CCB 5156
Pre and Post Change Summary
PCN #: CADA-13DJIO298

LEAD FRAME COMPARISON

EFTEC64T

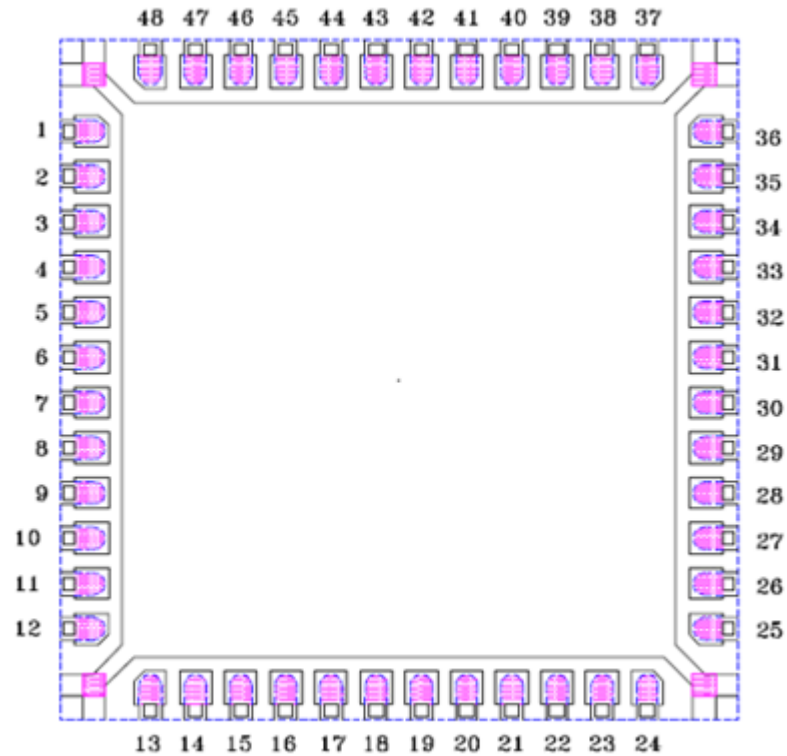
Lead frame Paddle Size

193x193 mil

C194

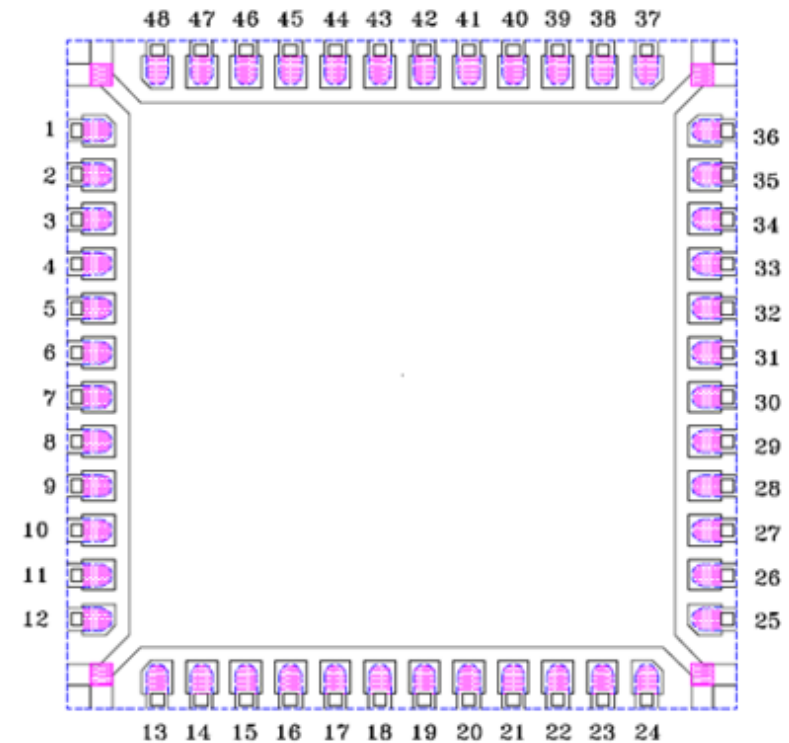
Lead frame Paddle Size

193x193 mil
